**U.S. Nuclear Regulatory Commission Meeting
with Nuclear Energy Institute, Material Reliability Program, and
Operating Pressurized Water Reactor Licensees'**

Purpose: To discuss NRC staff's technical assessment for vessel head penetration nozzle cracking associated with NRC Bulletin 2001-01, "Circumferential Cracking of Reactor Pressure Vessel Head Penetration Nozzles."

**NRC-FUNDED
CRDM STRESS ANALYSIS, CRACK-DRIVING
FORCE, AND LEAK-RATE ANALYSES**

**NRC-FUNDED
CRDM CRITICAL CRACK SIZE ANALYSES**

Figure 15 Estimated stress intensity factor K for a CRDM nozzle based on SIA and ORNL results.

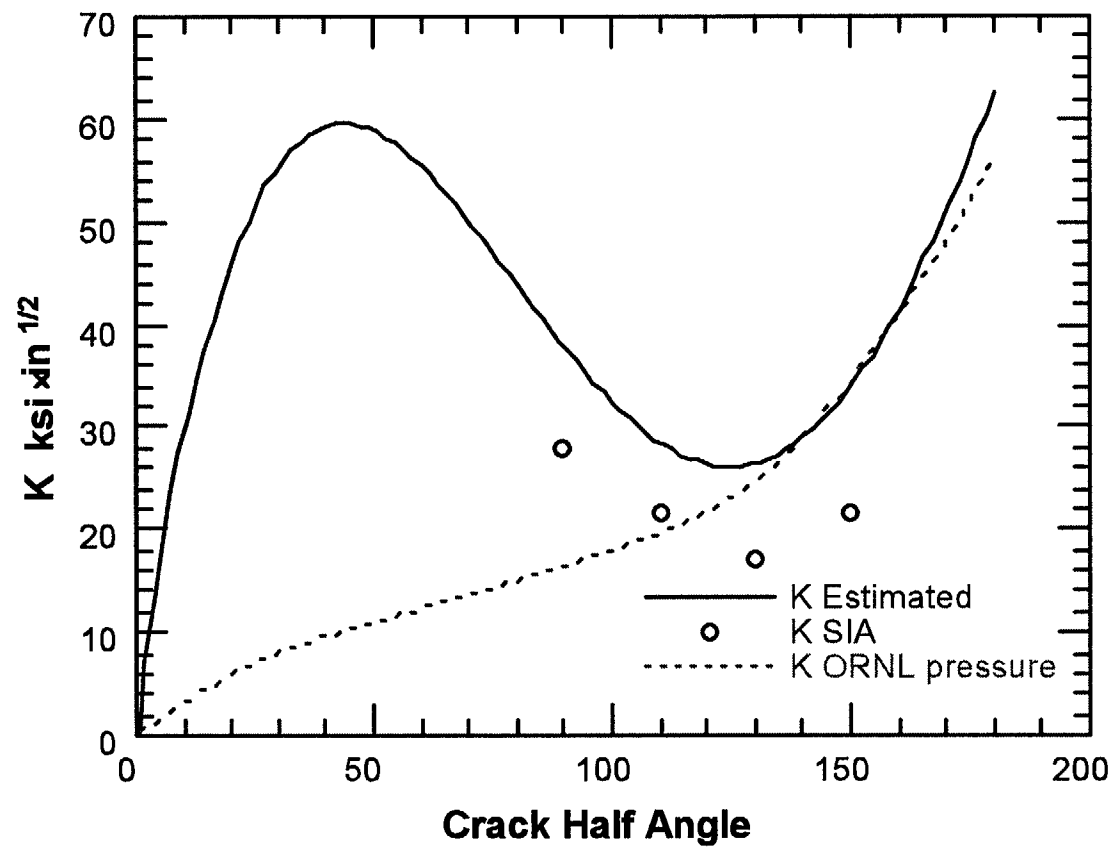
- A single estimate for K as a function of circumferential crack length was provided (with a value of $66 \text{ MPa}\sqrt{\text{m}}$ ($60 \text{ ksi}\sqrt{\text{in.}}$) due to residual stresses for a crack angle of 90°)

Figure 20 Evaluation of operating time to reach critical flaw sizes at three times design pressure and at nozzle failure/ejection after development of a 165° long circumferential through-wall flaw.

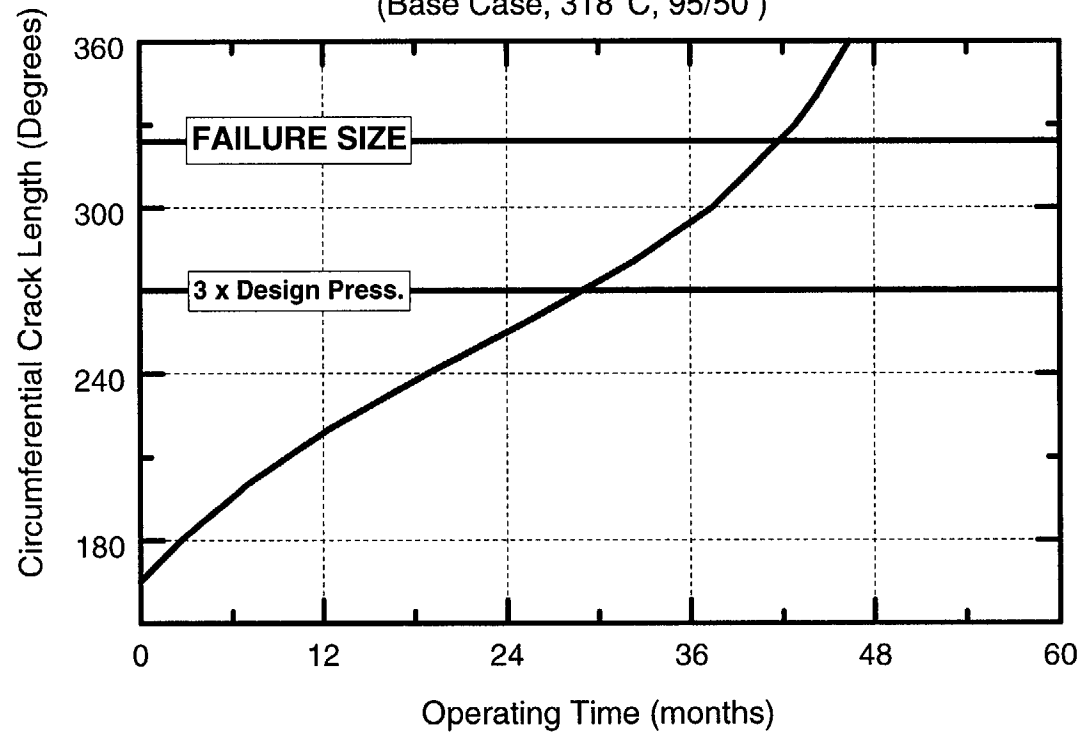
- Critical Flaw Size
 - 270° with a safety margin of three on pressure
 - 324° for nozzle failure and possible ejection
- Crack Growth Rate
 - 95/50 statistical bound
 - 318°C (605°F)
 - A for Scott model is 1.303×10^{-11}
- Initial Flaw Size
 - Unknown - basis for issuance of the Bulletin
 - Used as a parameter

Figure 23 Crack growth analysis using various crack growth rate assumptions, from an initial flaw size of 165°. Although decreasing the temperature has some effect, the most dramatic increases in failure times occur with the mean crack growth curve instead of the 95/50 curve.

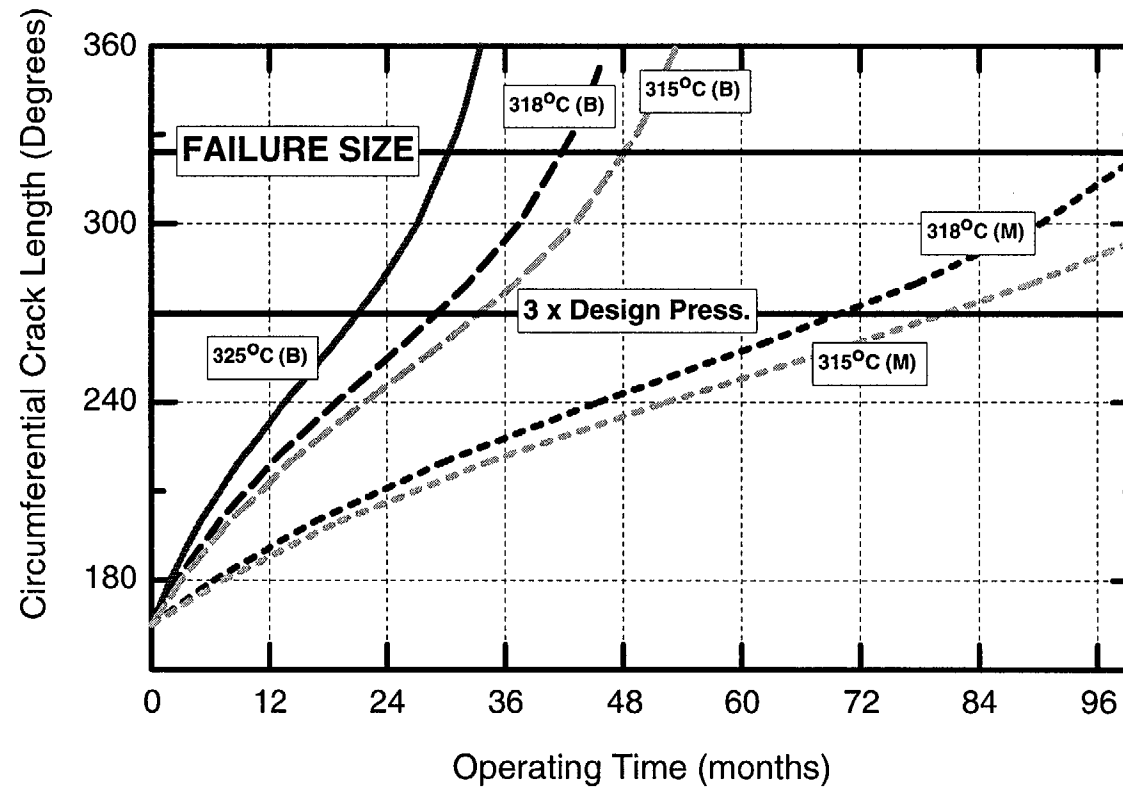
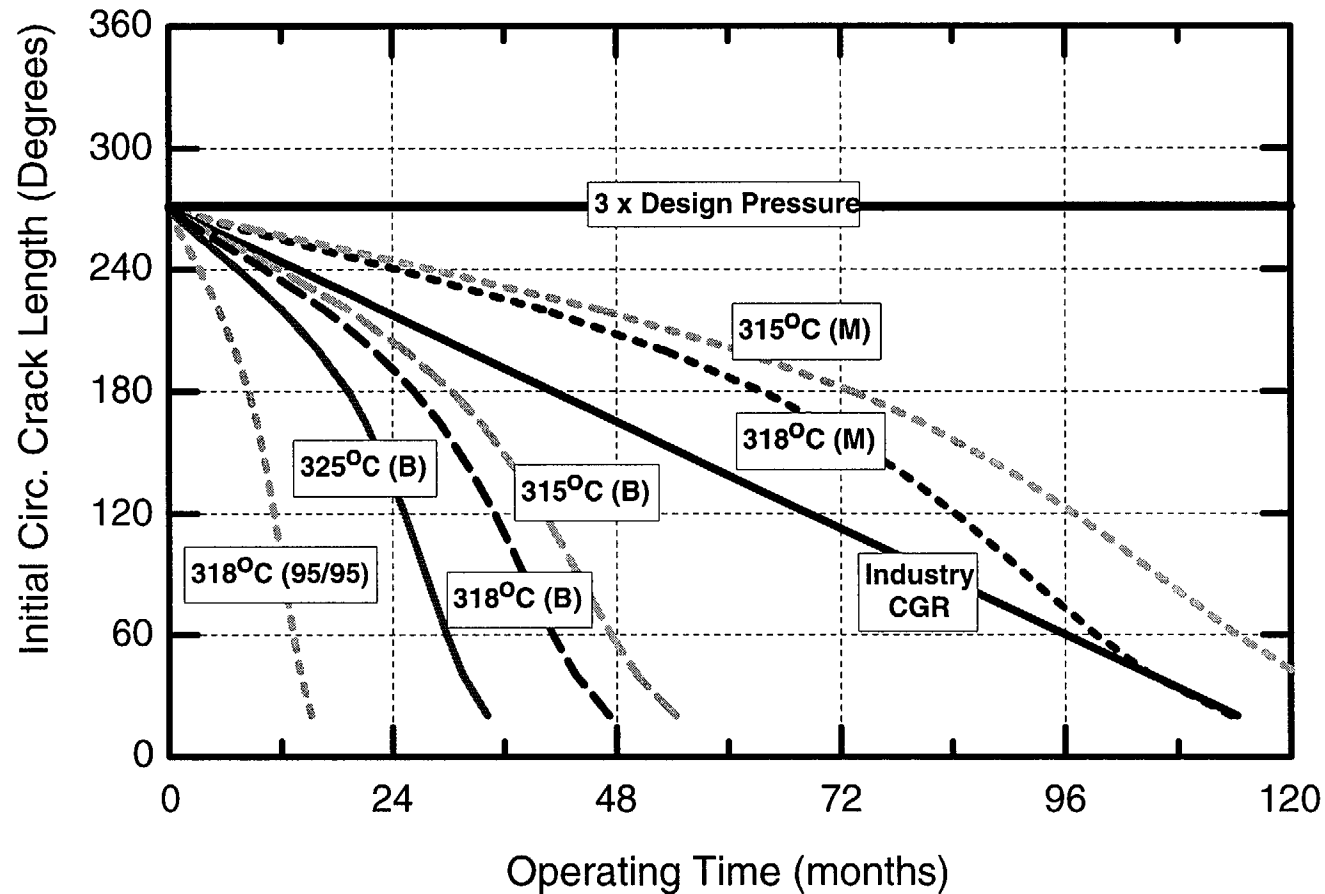
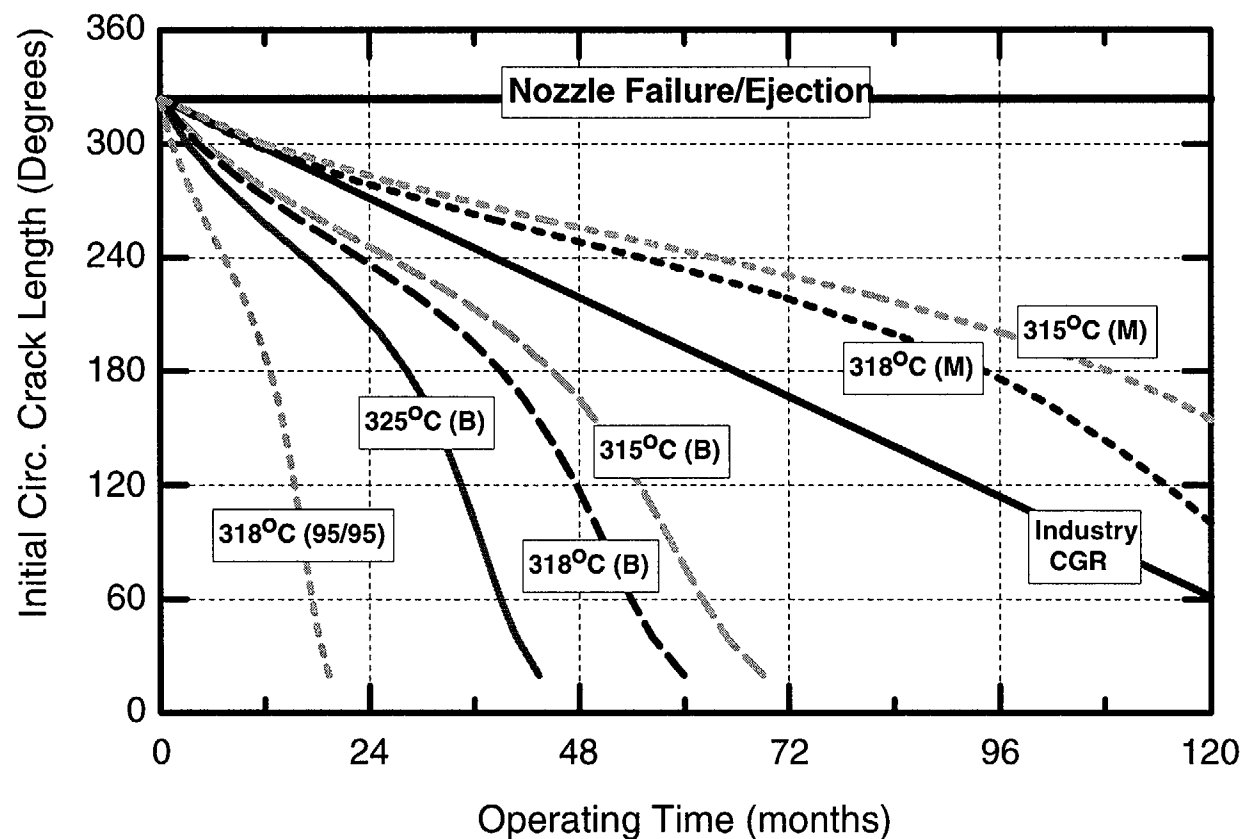
- ▶ Can use Figures 23 to 25
- ▶ New circumferential cracking can initiate
